MCP98242 Rev. A1 Silicon Errata

The MCP98242 family devices that you have received conform functionally to the current Device Data Sheet (DS21996B), except for the anomalies described in this document.

FIGURE 1: Flow Chart.

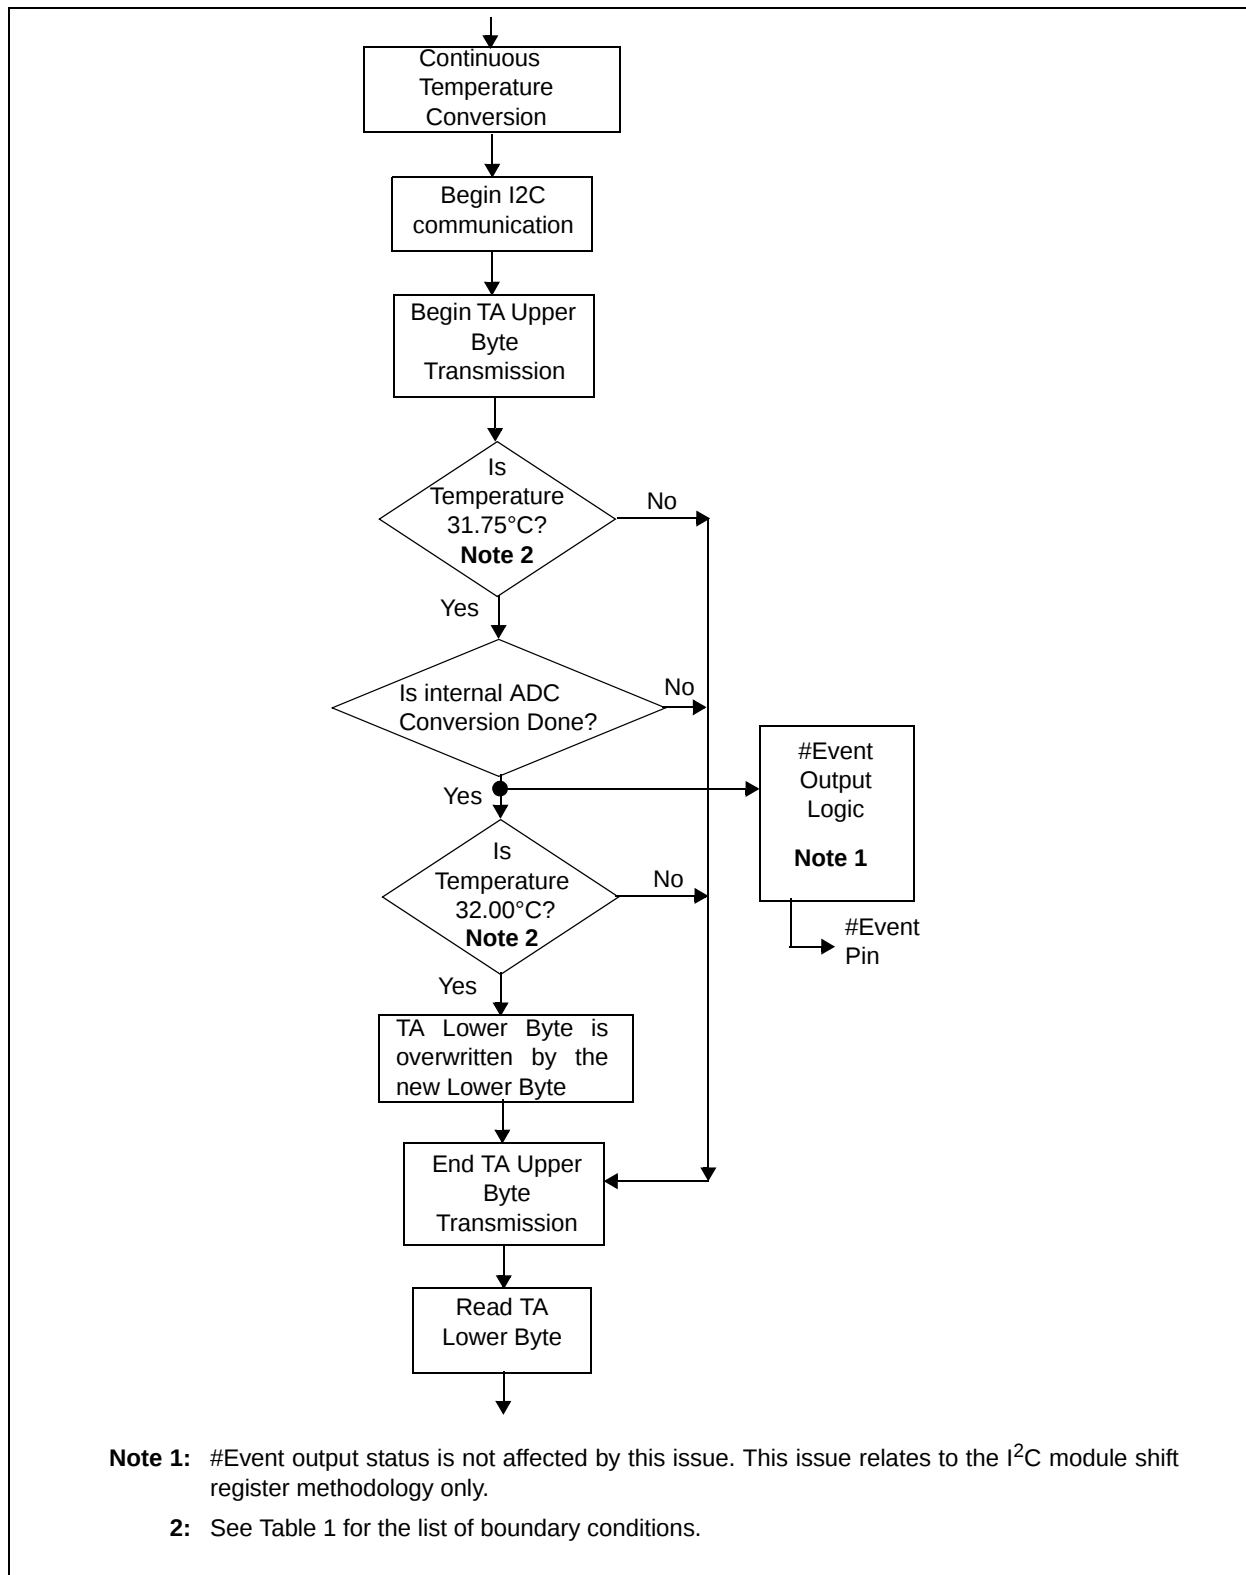
Under the specific boundary conditions listed below, the 2 byte temperature register T_A may contain temperature data $+16^\circ\text{C}$ or -16°C from the nominal temperature due to internal data synchronization issue.

- a) If the Lower Byte of the T_A register rolls up or down:
 - from '1111 1100'b to '0000 0000'b
 - from '0000 0000'b to '1111 1100'b
- b) If the internal ADC conversion completes ($T_{\text{CONV}} = 65 \text{ ms}$) while the Upper Byte is in transmission via the $I^2\text{C}$ bus.

Under these two conditions, the temperature reading may jump up or down by 16°C .

Byte 1 must be in $I^2\text{C}$ transmission for this issue to occur and the ADC must complete conversion while $I^2\text{C}$ is in communication. In addition, the ambient temperature must be at multiples of $16^\circ\text{C} \pm 0.25^\circ\text{C}$ for the temperature register to be partially overwritten.

Figure 1 shows flow diagram describing the specific conditions for the synchronization issue occurs. Table 1 shows a complete list of temperatures greater than 0°C.

If the ambient temperature read is within the host temperature limit, then do nothing. Otherwise, if the new temperature read is greater than or less than the previous temperature data by exactly 16.00°C, then perform a Repeat Read to receive the correct temperature data. There is a 0% probability that the Repeat Read data would be corrupted, if the Repeat Read is performed within T_{CONV} (65 ms). If a Repeat Read is performed after 65 ms then there is a greater than 0% probability that the next conversion would also be corrupt by ±16.00°C as stated in Table 1. In this case, disregard this reading and perform a Repeat Read and compare the result with the last known good reading.

Devices on or after date code 0847 correct this issue. **The Device ID/Revision Register for these parts is set to 0x2000 hex.**
